ADDENDUM No. 1

RFP No. 25-01

2025 Miscellaneous Utility Projects

SHEET No. **25 OF 52**

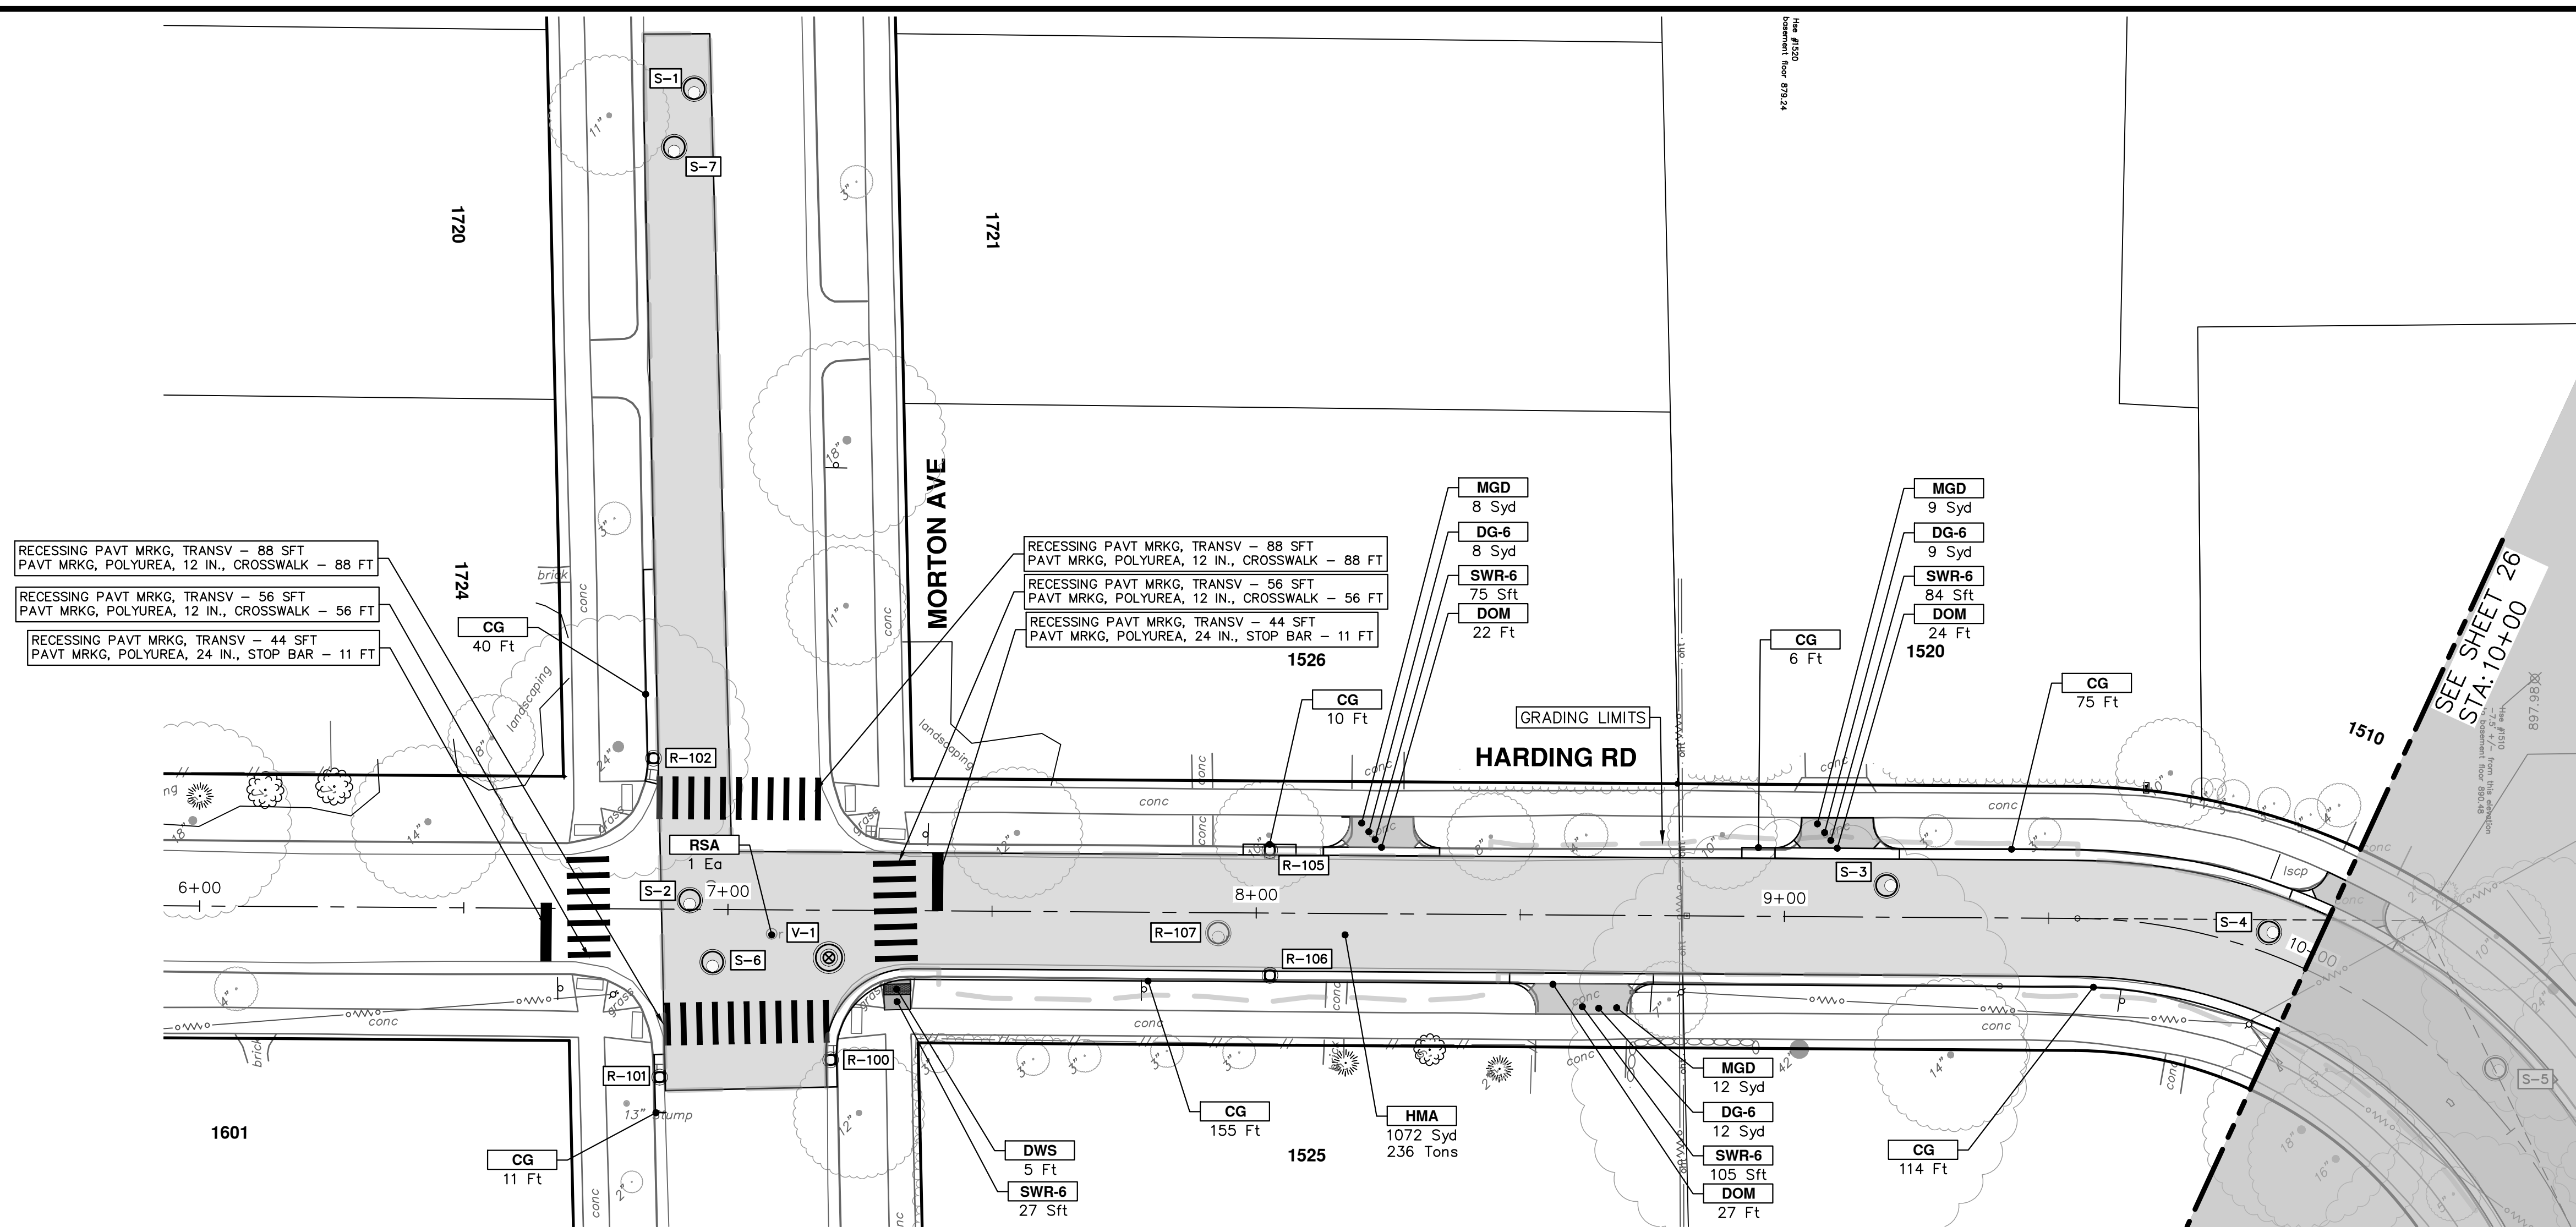
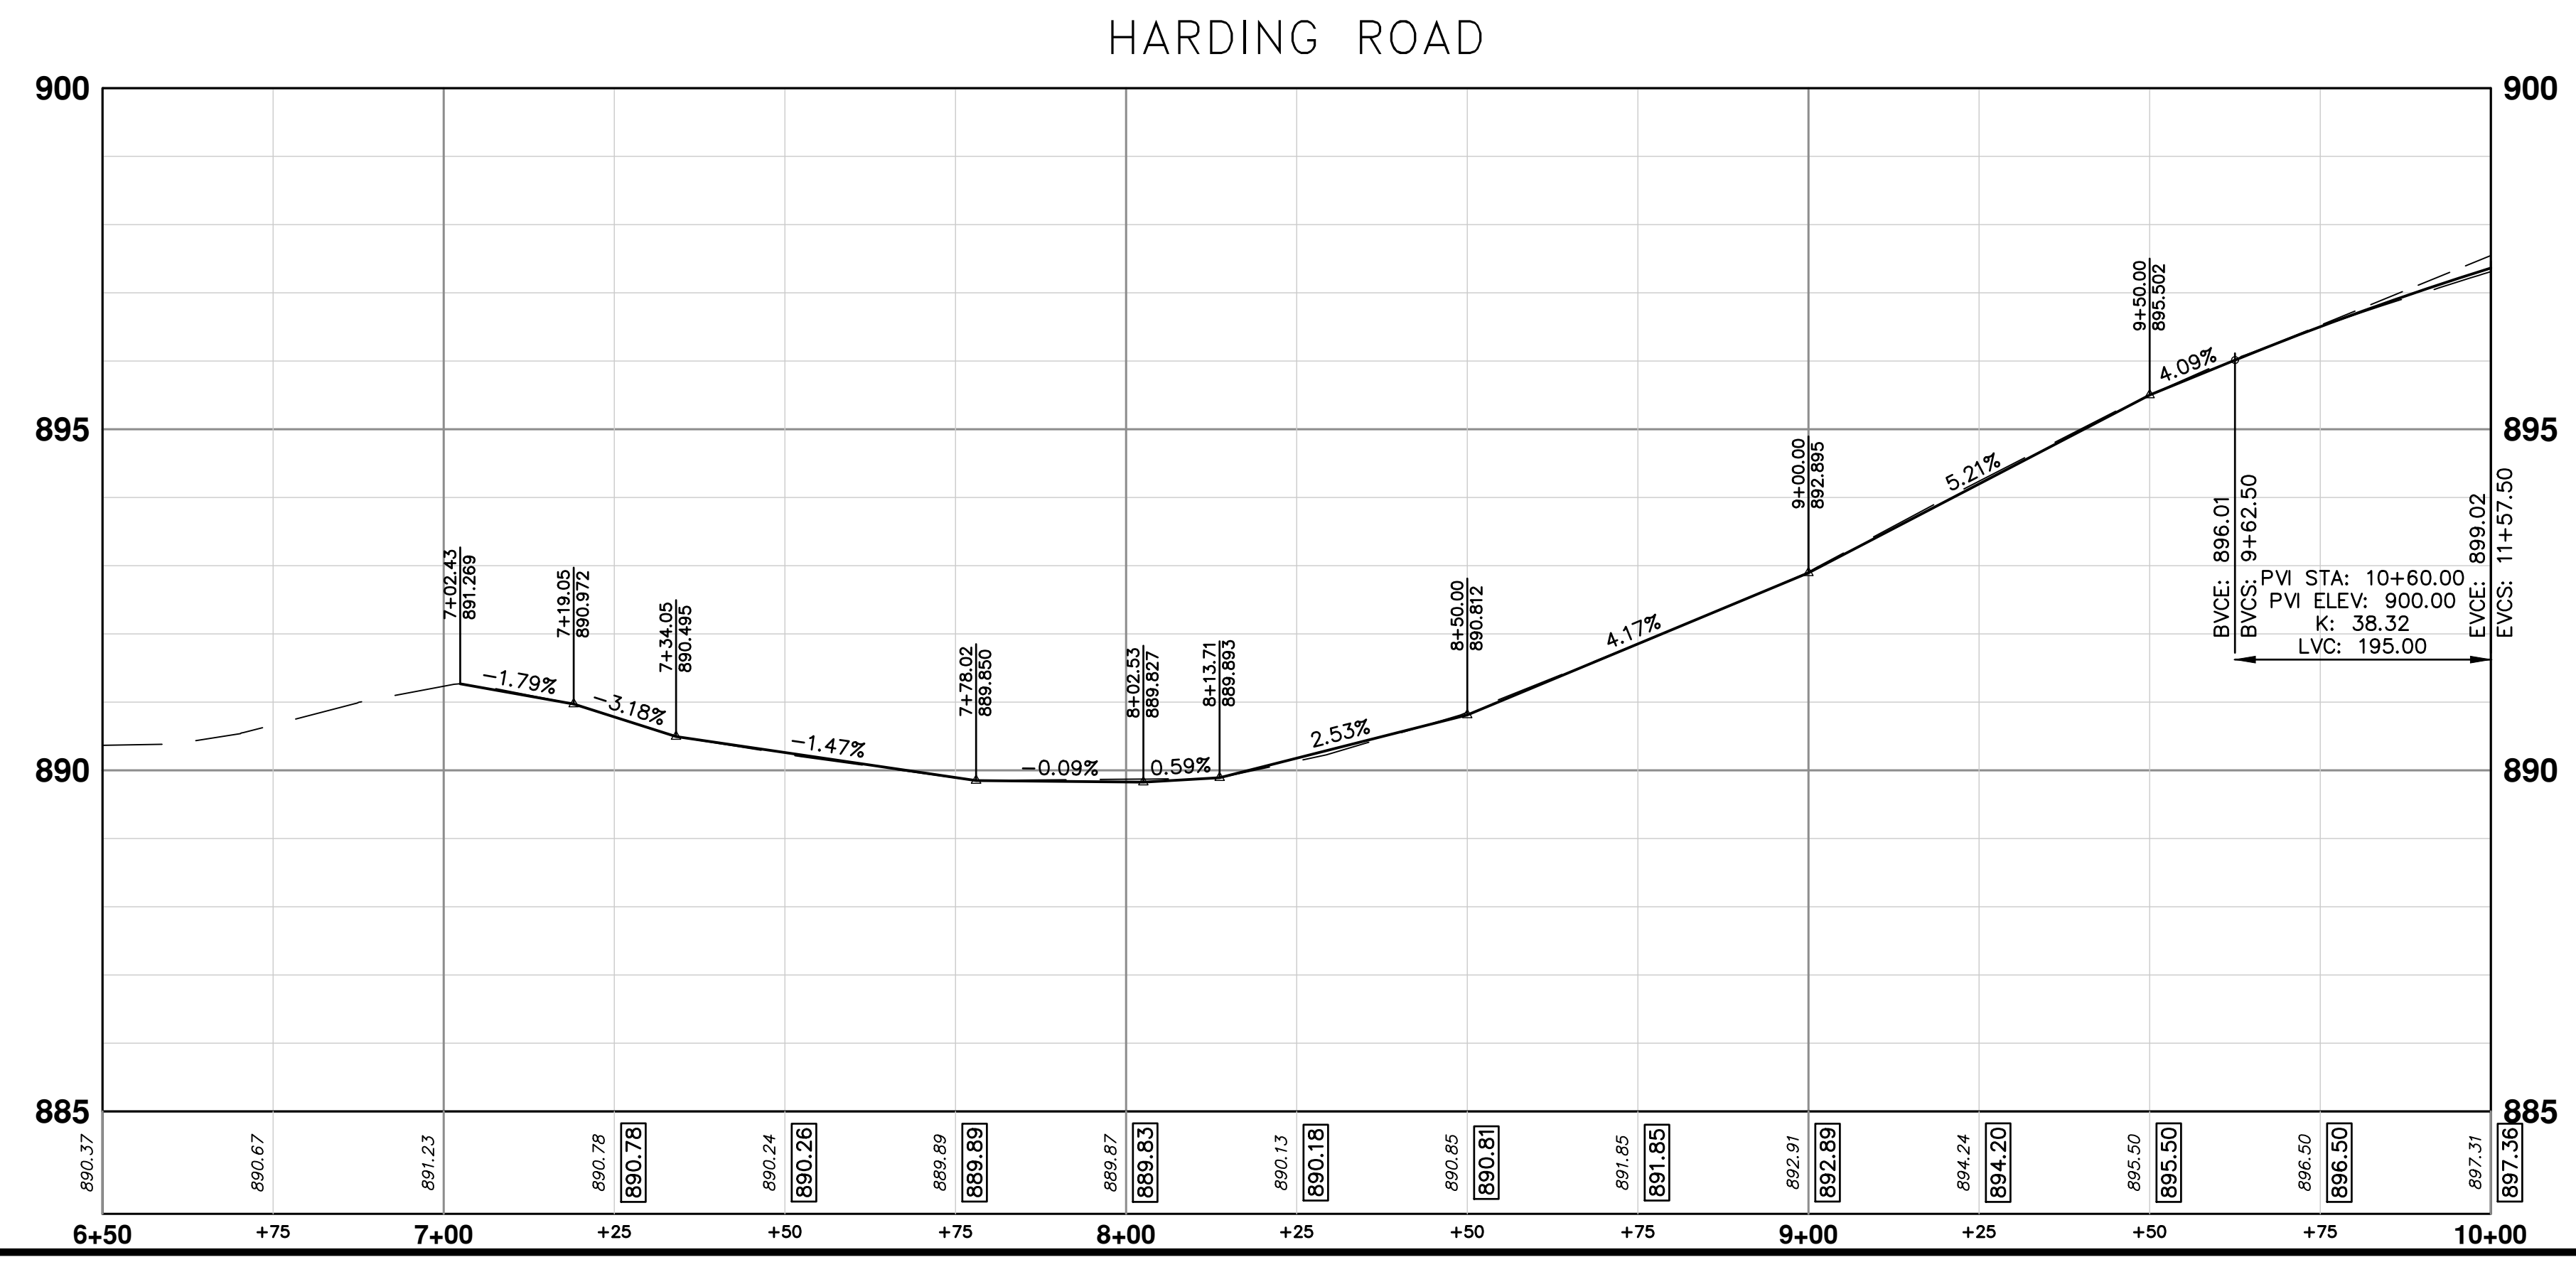
Sheet 25: Hatching removed from profile (CAD error)
